<b>MODEL</b>	F20 Sorter	<b>VOLT/Hz</b>	<b>DATE OF MODIFICATION</b>	<b>SERIAL NO.</b>
<b>MODIFIED ARTICLE</b>	Parts Catalog			
<b>REASON OF MODIFICATION</b>

Please correct your parts catalog as follows:

\* : New Index No. (See Figure)

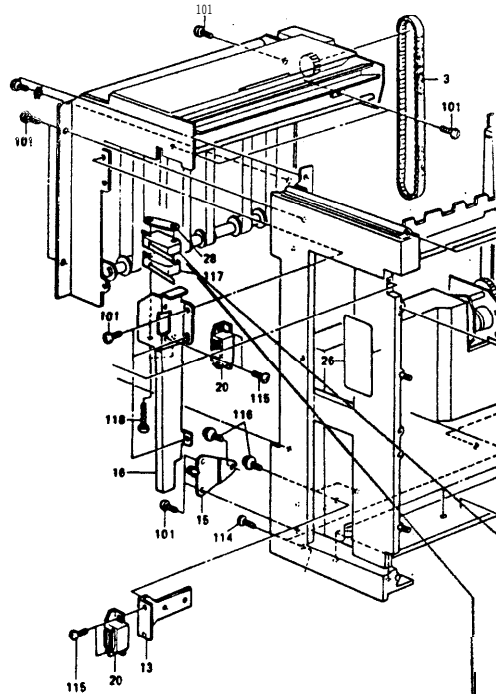
P/N	Description	Q'ty	Index No.	Page
58874520	Insulating Sheet	2 (115V) 3 (220V)	*33	3-5

1. EXTERIOR (Page 3-4)

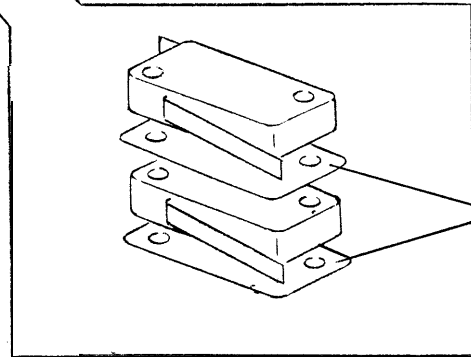
The insulating sheets (#58874520) have not been listed on page 3-4, please add them accordingly.

#33 (Insulating Sheet)

5. DRIVE SECTION (Page 3-12)

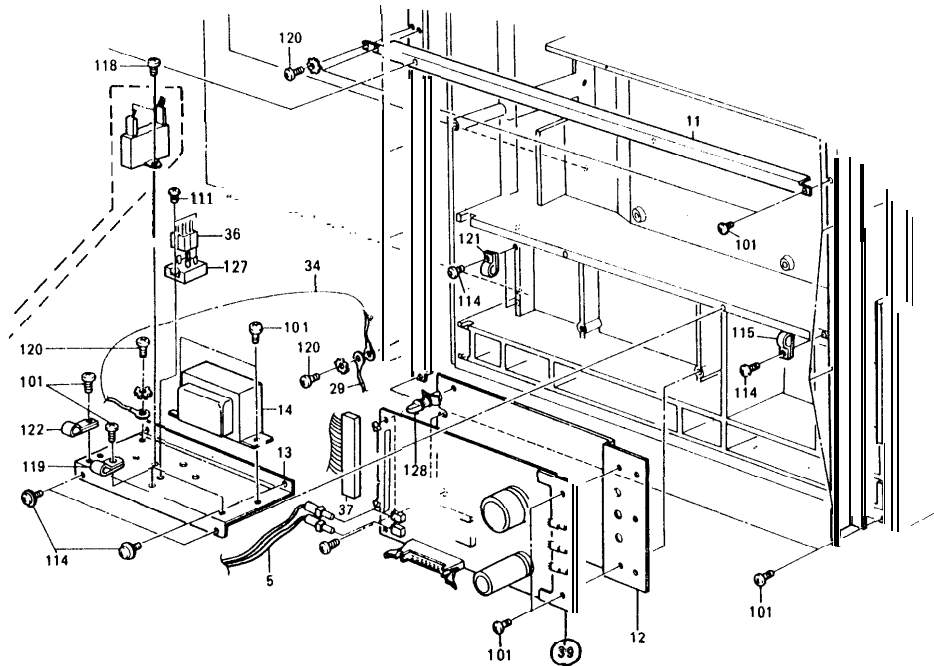
Sorter main P. C.B.  
 #59375611 → 59375612

To enable second sorter operation, the ROM on the sorter main board has been changed from #59375603 to #59375613. Thus, the sorter main board has been changed from #59375611 to #59375612. As we informed separately, the suffix of the latest ROM (#59375613) is "B".

3. TRANSPORT 2 (page 3-8)

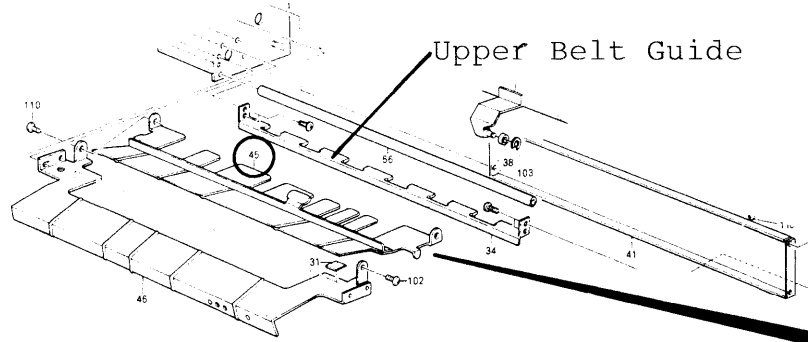
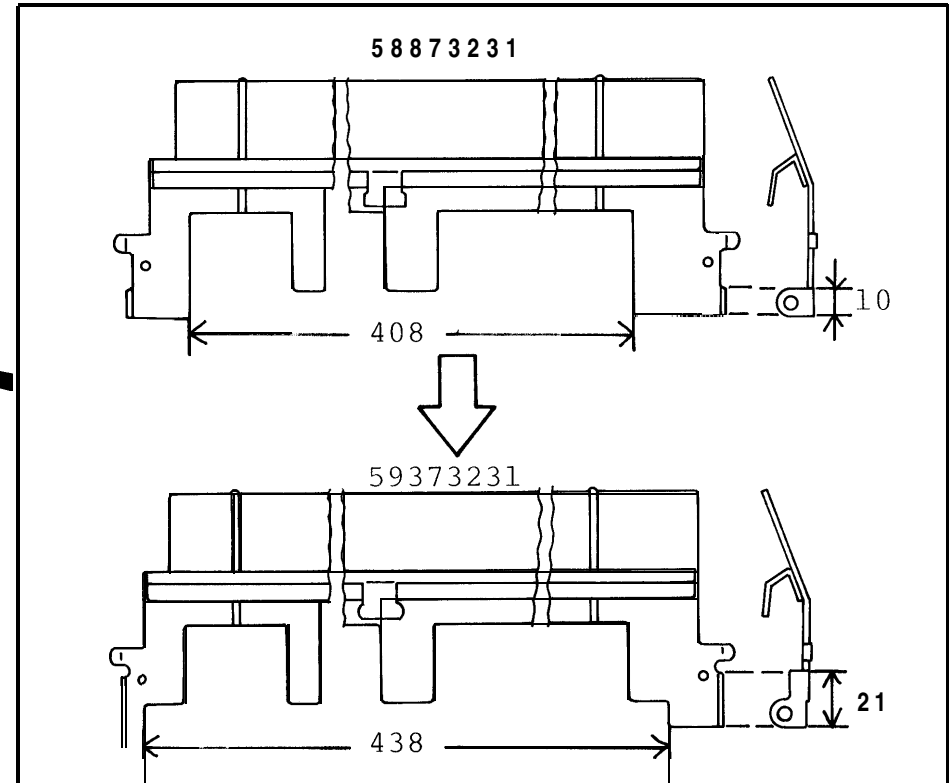
If paper misfeeds in the sorter, and the paper remains behind the upper transport belts, then the misfed paper should be removed by rotating the knob at the front of the lower belt drive roller. (Please refer to page 50 in the F20 operating instructions.) However, some of the customers remove the misfed paper without using the knob. Thus, the belt may sometimes come off the rollers (belt drive roller or belt tension roller).

To reduce the possibility of this problem, higher guides have been added to the rubber part of the belt tension roller marked 'entrance side' in the figure and the belt drive roller has been made wider. According to this modification, the receiving upper guide has also been changed.

To standardize with the modified belt tension roller, the other one marked 'exit side' in the figure has also been changed with an interchangeability of o/o.

When you replace the old belt drive roller with the new one, the installation procedure of the upper belt guide will be changed.

Please refer to F20 RTB No.12.

3. TRANSPORT 2 (page 3-8)

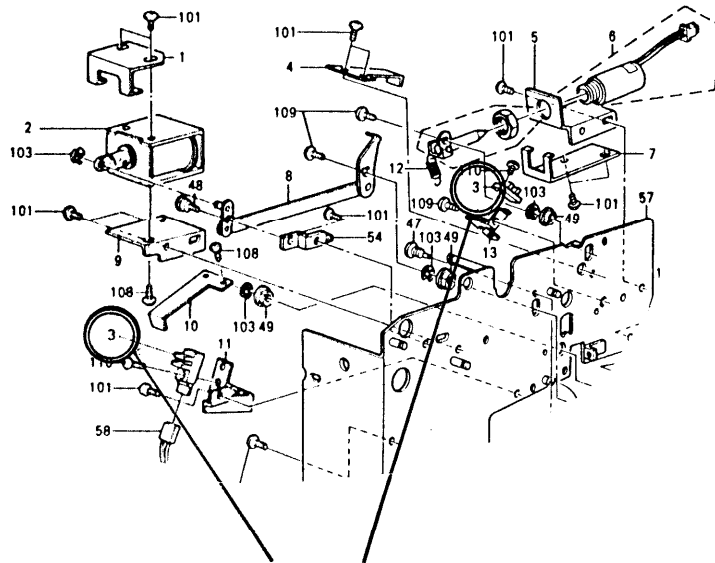
As per vendor change, the photo sensors have been modified from 54425379 to AW020002 with an interchangeability of 0/0 .

\* New Index No. (See Figure)

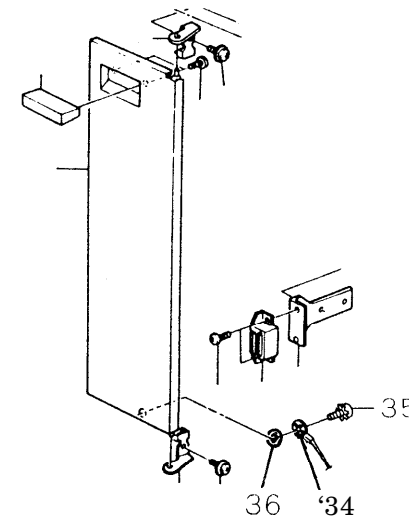
P/N	Description	Q'ty	Index No.	Page
58875782	Grounding Wire - Front Cover	1	*34	3-5
03140060M	Philips Pan Head Screw - M4x6	2	*35	3-5
07040040M	Toothed Washer - M4	2	*36	3-5

5. DRIVE SECTION (Page 3-12)

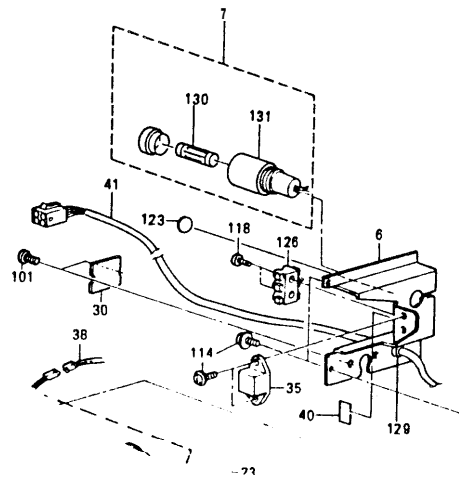
To standardization with other models, the fuse holder case has been changed. This fuse holder case (#11040345) is to meet UL and CSA standards.

According to the above modification, the fuse, fuse holder and power supply cord bracket have been changed.

These new parts should be replaced as a set.

2. TRANSPORT 1 ( Page 3-6 )

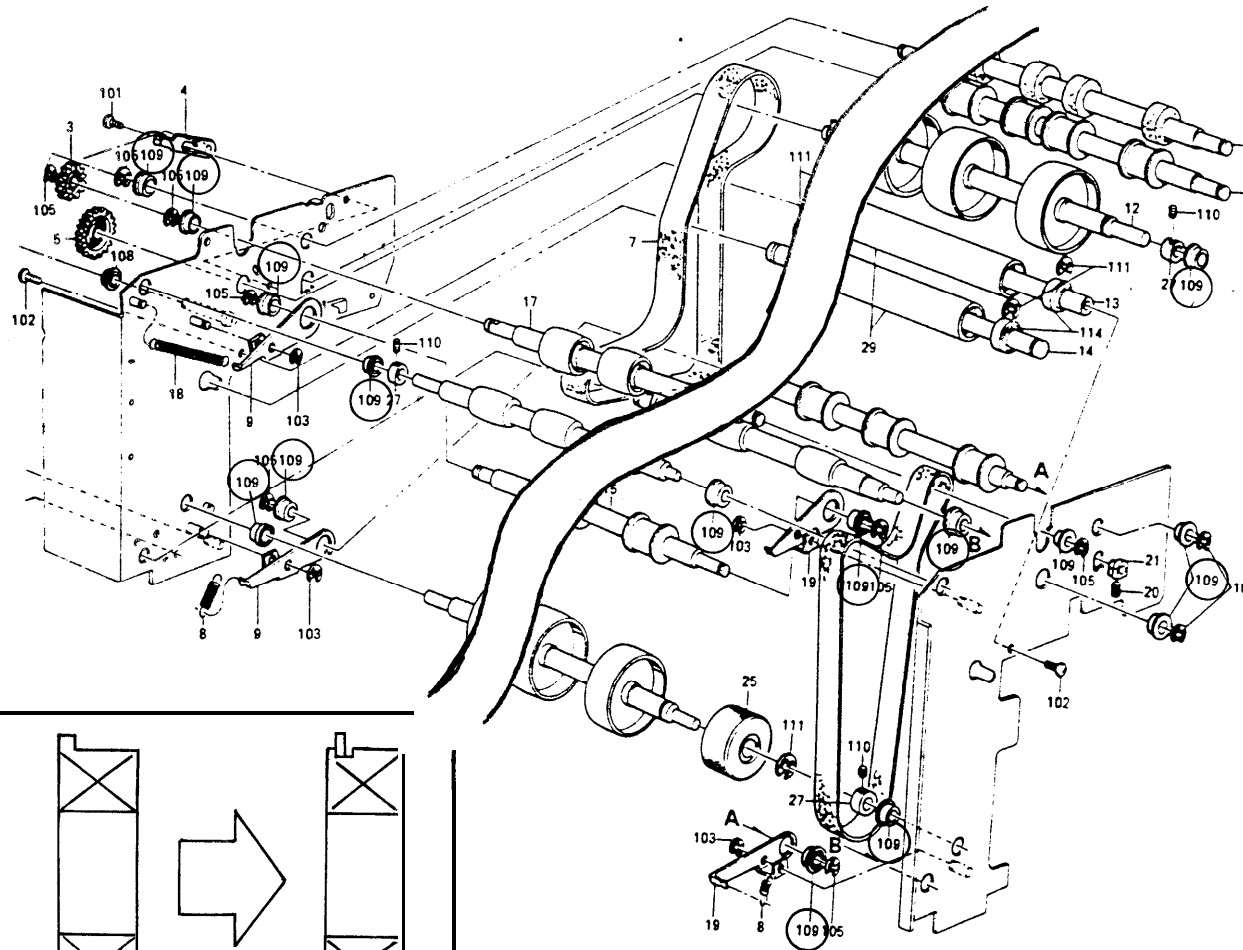
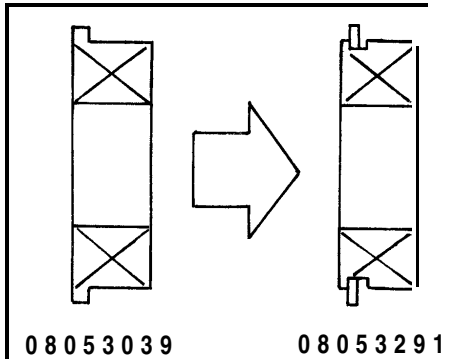
To ensure positive rotation of rollers, the shape of the ball bearing has been changed as shown in the figure. The new ball bearings all should be replaced at the same time.

5. DRIVE SECTION (Page 3-12)

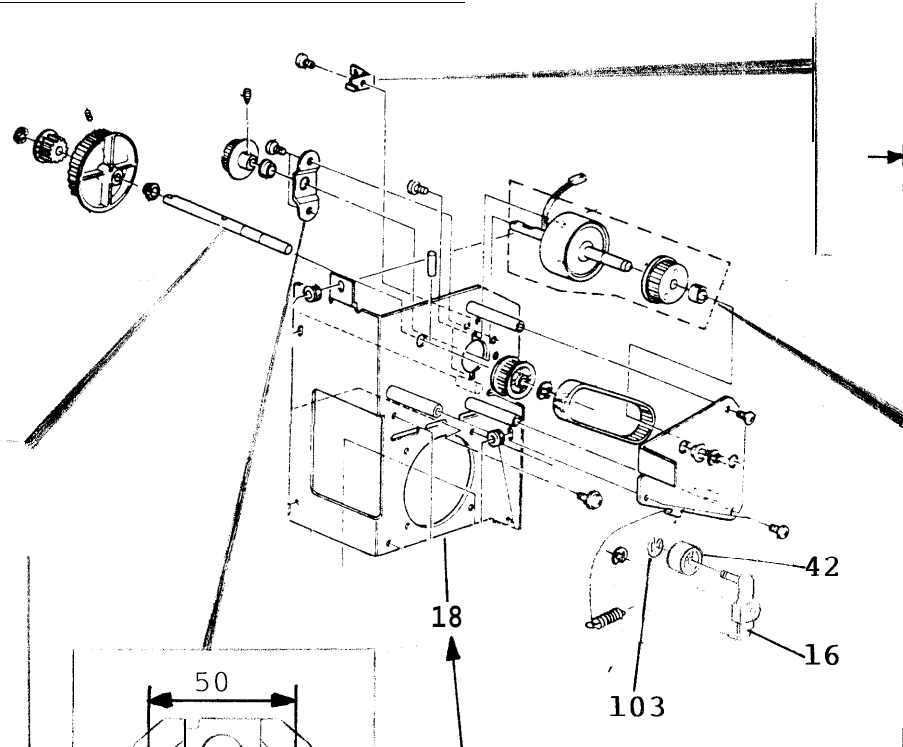
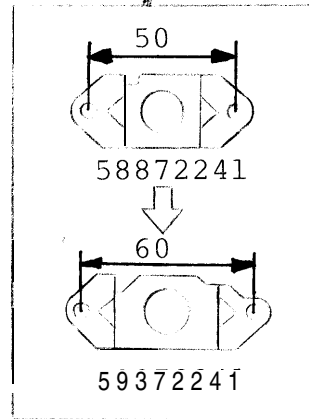
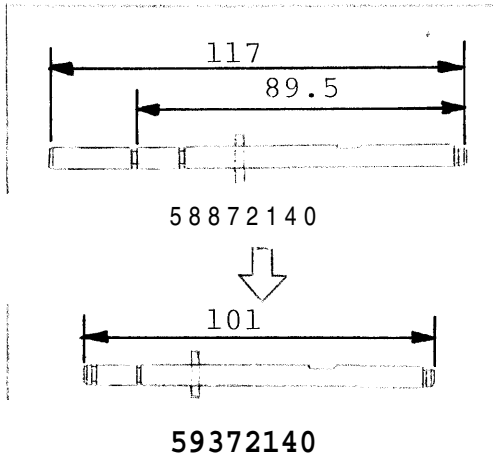
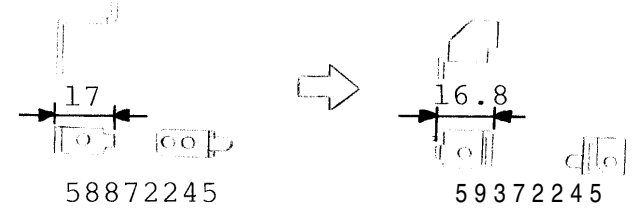
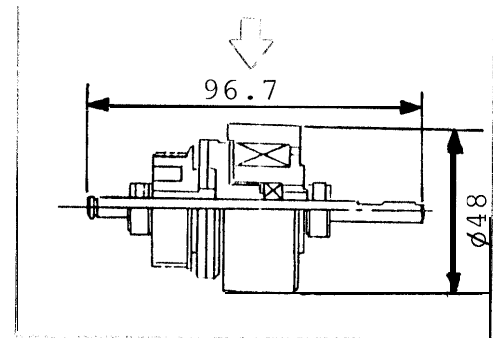
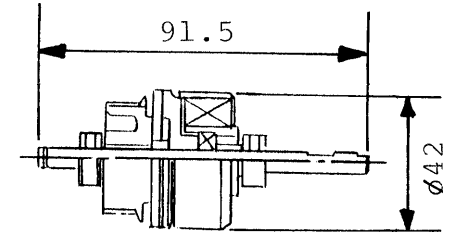
18  
 This part also should be replaced at the same time.

When oil of ball bearing adheres to the magnetic clutch, the stiction torque of the clutch sometimes comes to approximately 1/2 as compared with usual value and comes to less than the load of the clutch shaft. The result is that the clutch will slip.

To increase a margin of magnetic clutch, the magnetic clutch has been changed to a new one which has larger torque.

According to this modification, the shape of the clutch idler tension, driving shaft, support plate and spring anchor has been changed as shown in the figure.

The interchangeability code for all modified parts is X/O. Therefore, the new parts (including #59372110) should be replaced as a set.

5. DRIVE SECTION (Page 3-12)

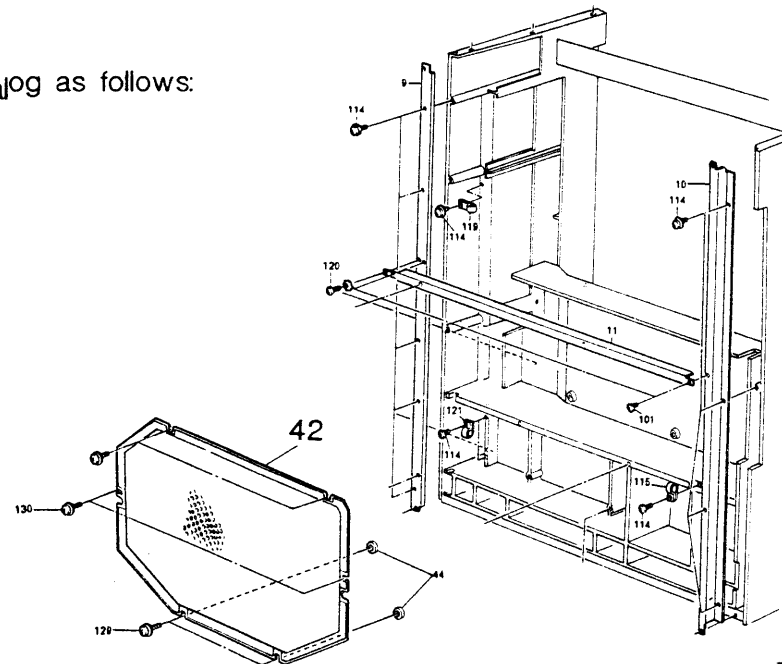
Page	Index No.	Part Number	Description	Q'ty
3-13	42 (New Index)	#59374470	Cover - Main Control (115V)	1

Please add the illustration of the above cover to your parts catalog as follows:

4 Distribution (Page 3 - 10)

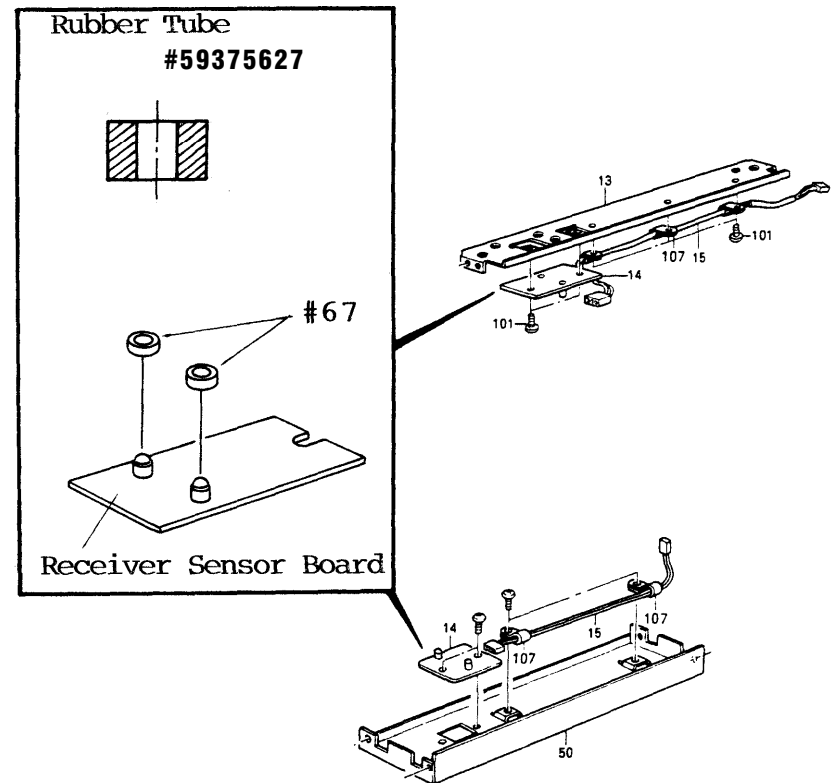
To meet FEMKO standards, rubber tubes (#59375627) have been applied around the photosensors on the receiver sensor board.

18. DECAL AND DOCUMENT (Page 3-38)

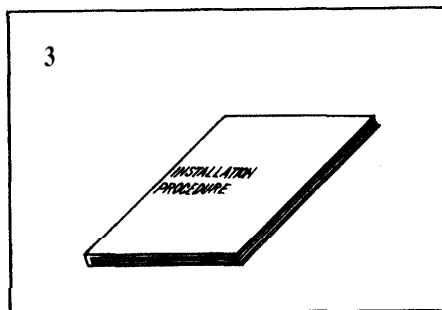
Page	Index No.	Part Number	Description	Q'ty	
3-39	3 (New Index)	#59378721	Installation Procedure - English	1	(Ricoh version)
3-39	3 (New Index)	#59378722	Installation Procedure - Multi	1	(Ricoh version)
3-39	3 (New Index)	#59374850	Installation Procedure - English	1	(OEM version)

3. TRANSPORT 2 (Page 3-8)

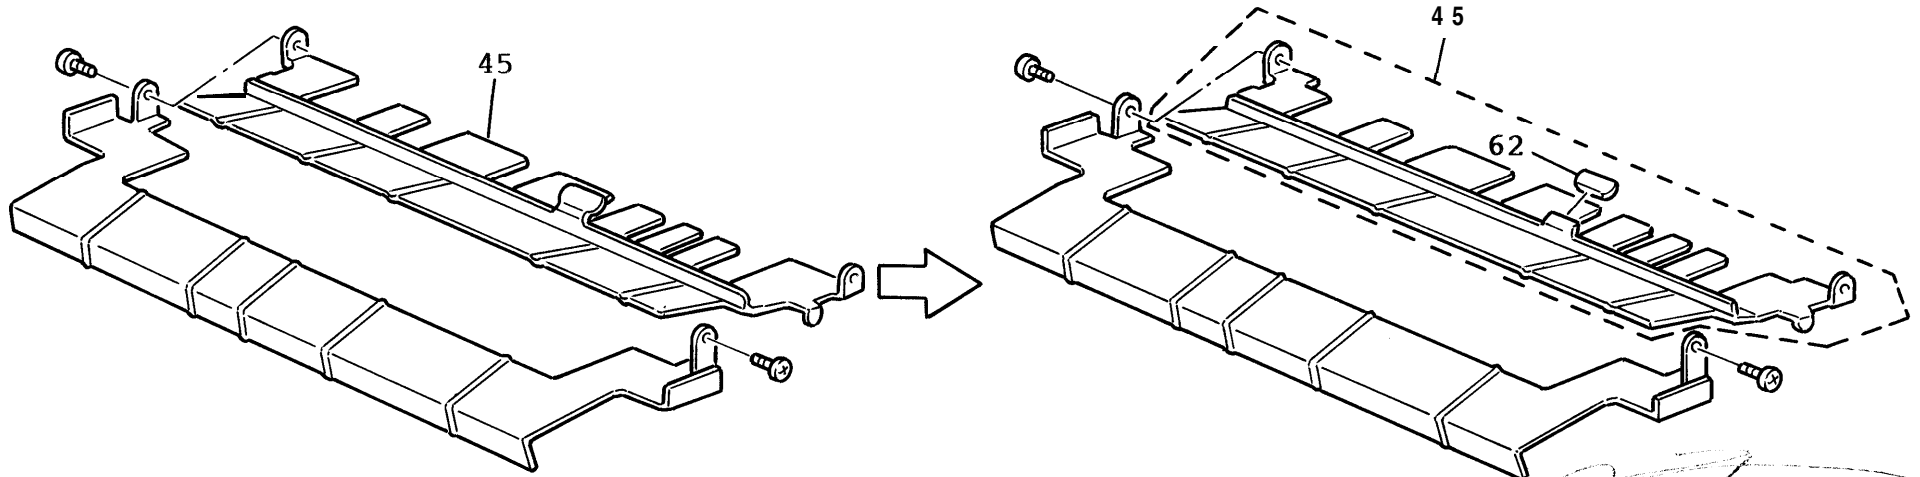
Page	Index No.	Old P/N	New P/N	Description	Q'ty
3-9	45	*59373231	#59373230	Receiving Upper Guide	1
3-9	62 (New Index)		#67541242	Knob Cap	1

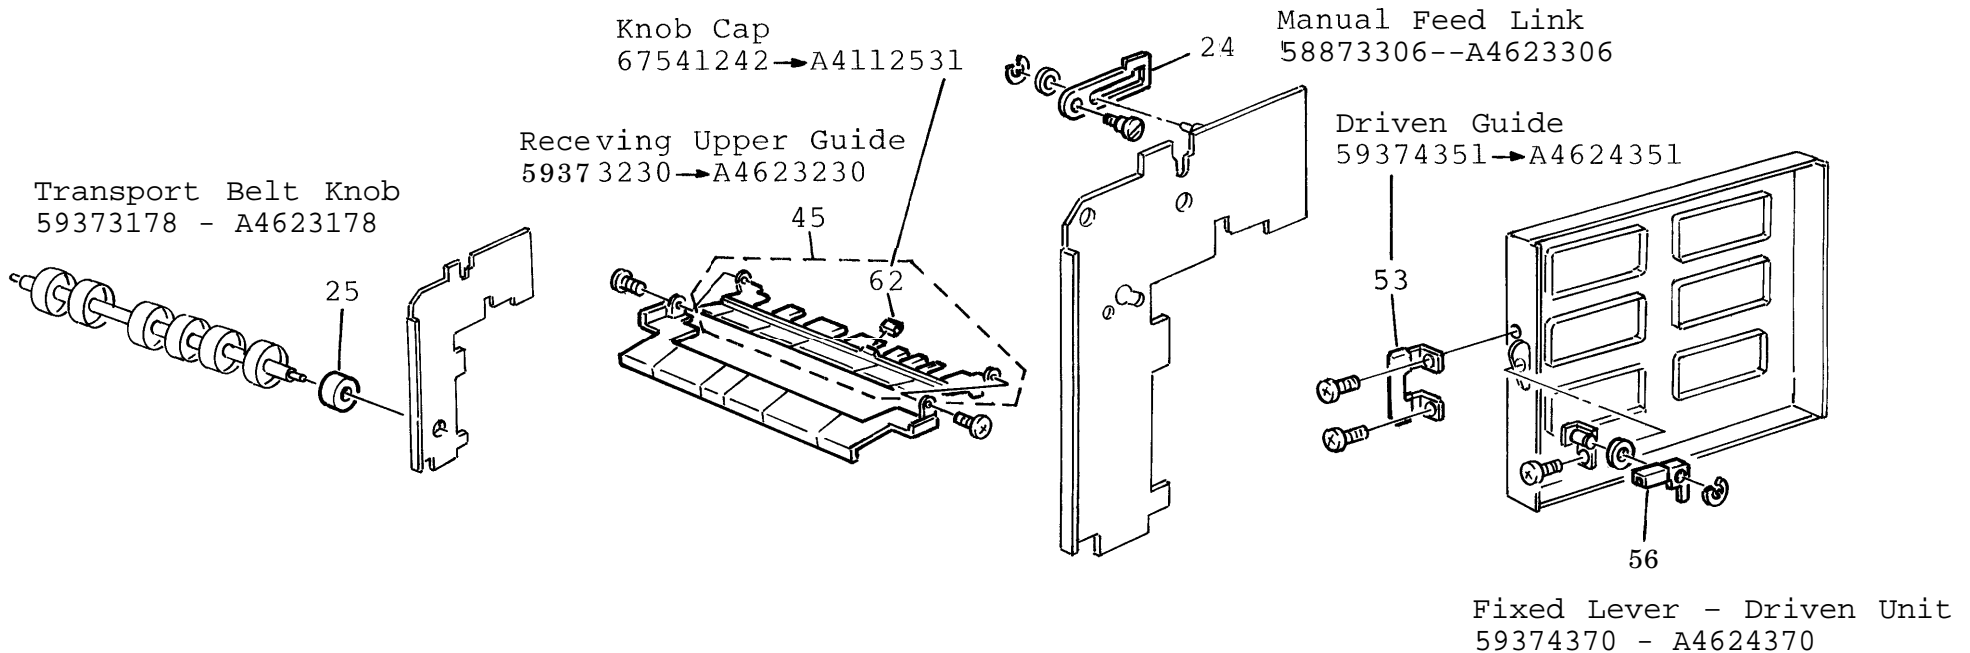
In the Pitney Bowes, Savin, and Nashua version machines, the sorter for the F20 will be commonly installed onto the F21. As per color standardization with the F21, the color of the parts listed Page 1 of this bulletin has been changed. The following show the locations of the parts catalog:
